UNITED STATES PATENT AND TRADEMARK OFFICE

APPLICATION NO.	FILING DATE	FIRST NAMED INVENTOR	ATTORNEY DOCKET NO.	CONFIRMATION NO.
10/823,164	04/13/2004	Manimaran Muthiah	10013.0005US	3738
33197 7590 12/10/2007 STOUT, UXA, BUYAN & MULLINS LLP 4 VENTURE, SUITE 300 IRVINE, CA 92618			EXAMINER VAINBERG, SIMON	
			ART UNIT 1797	PAPER NUMBER
			MAIL DATE 12/10/2007	DELIVERY MODE PAPER

Office Action Summary	Application No. 10/823,164	Applicant(s) MUTHIAH ET AL.	
	Examiner Simon Vainberg	Art Unit 1797

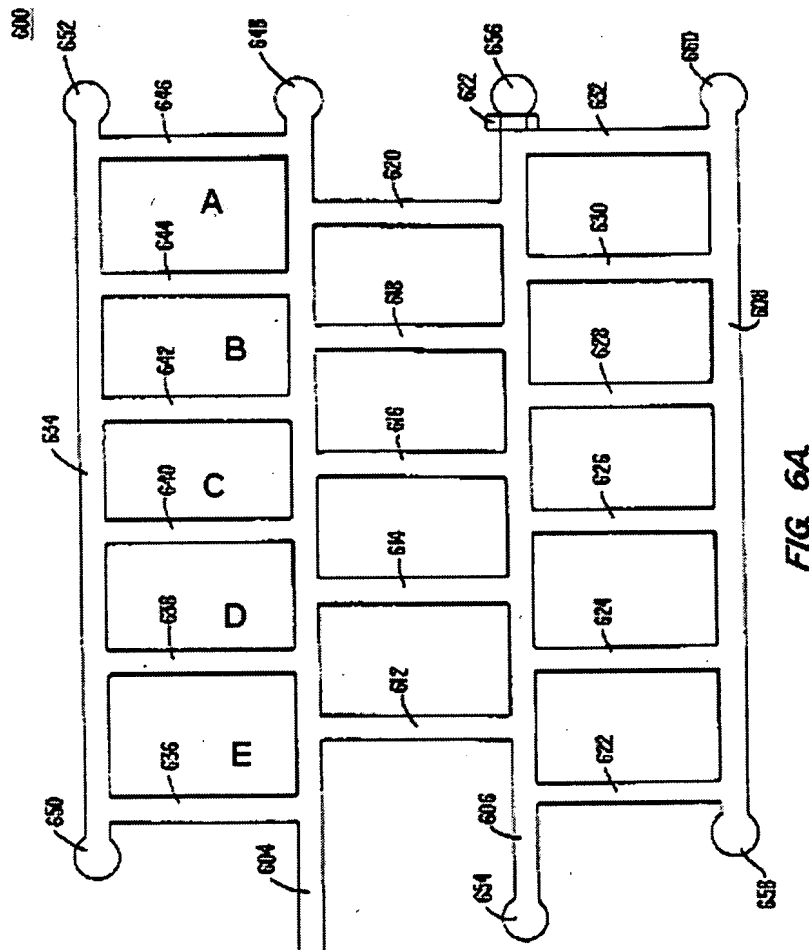
Regarding claim 1, the Parce et al. (US Patent 5942443) reference teaches a device comprising: at least two channels being separated by a partitioning wall therebetween (see Fig. 6A, channels 634 and 604), wherein each channel has an inlet and an outlet (Fig. 6A numbers 650 and 652), and at least one through passage is defined in the partitioning wall to allow fluid communication between the two channels (see Fig. 6A, channels 634 and 604 are interconnected by channel 636).

The Parce et al. reference also teaches that at least two passages are defined in each of the at least one partitioning wall (see Fig. 6A, channels 634 and 604 and interconnected channels 636 and 638).

The Parce et al. reference further teaches that the partitioning wall comprises: two wall sections separated by a gap therebetween; and at least one partitioning element in the gap that divides the gap to form the two passages (see attached Fig. 6A, where A and C are two wall sections separated by gap between them and B is

partitioning element in the gap that divides the gap to form the two passages 644 and 642).

The Parce et al. reference further teaches a that the partitioning wall comprises at least two partitioning elements that divide the gap into at least three passages (see attached Fig.6A, where A and D are two wall sections separated by gap between them and B and C are two partitioning elements that divide the gap into three passages 644, 642 and 640).

The Parce et al. reference does not teach that partitioning elements are unevenly spaced apart to form passages of widths that vary along the length of the partitioning wall and the widths of the passages increases along the length of the partitioning wall.

Regarding claim 8, the Parce et al. and Austin et al. references teach a device according to claim 7, wherein the partitioning wall comprises m partitioning elements that divide the gap into at least $m+1$ passages (see attached Fig. 6A of the Parce reference, where, for example, A and E references are the wall sections separated by a gap between them and B, C and D references are three partitioning elements that divide the gap into four passages 644, 642, 640 and 638).

Regarding claim 9, the Parce et al. and Austin et al. references teach a device according to claim 7, wherein the partitioning elements are at least substantially evenly spaced apart to form passages of at least substantially equal widths (see attached Fig.6A of the Parce reference, where, for example, A and E references are the wall sections separated by a gap between them and B, C and D references are three partitioning elements that evenly spaced apart to form four passages 644, 642, 640 and 638 of equal widths).
